ADDENDUM NO. 2
COUNCIL BLUFFS ROOFS
HAIL DAMAGE REPAIRS
Council Bluffs, Iowa

HGM PROJECT #151212

DATE OF ISSUE: May 24, 2013

AD2 - A1-101-05242013

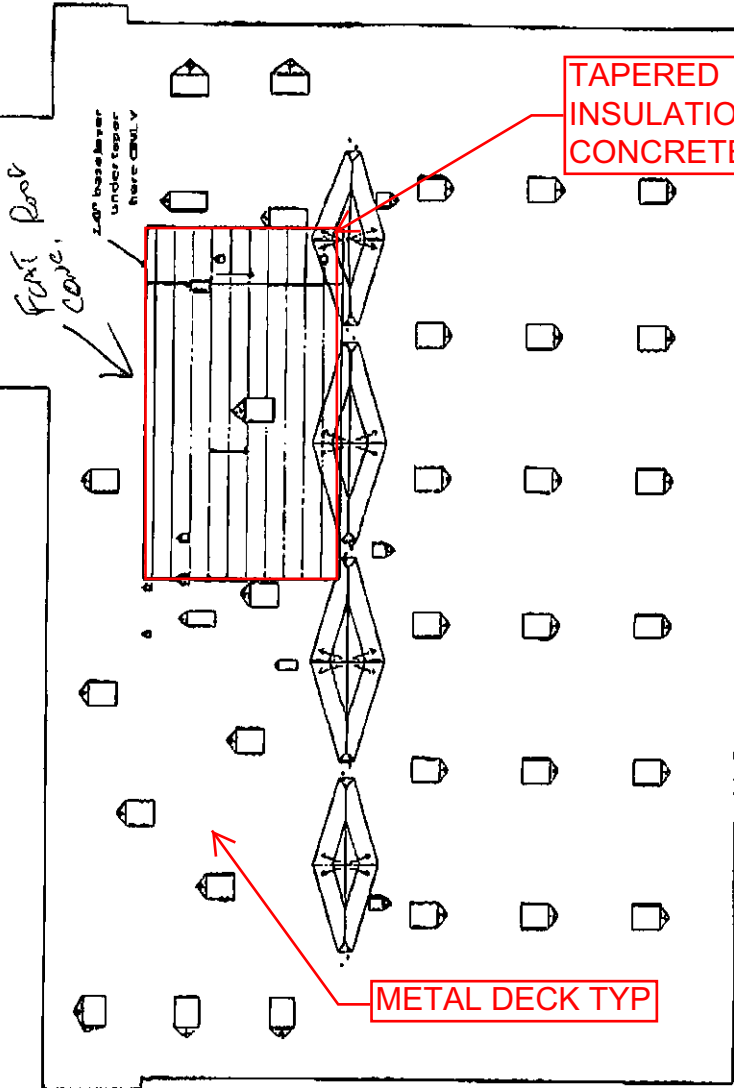
Refer to Construction Notes, note 3; Delete in entirety and add the following:

3. Provide fully adhered TPO over 1 layer ½" HD polyiso fully adhered to 1 layer 3" polyiso and 1 layer 2 ½" polyiso mechanically fastened to structure. Provide tapered insulation & crickets where indicated – See attached drawing.
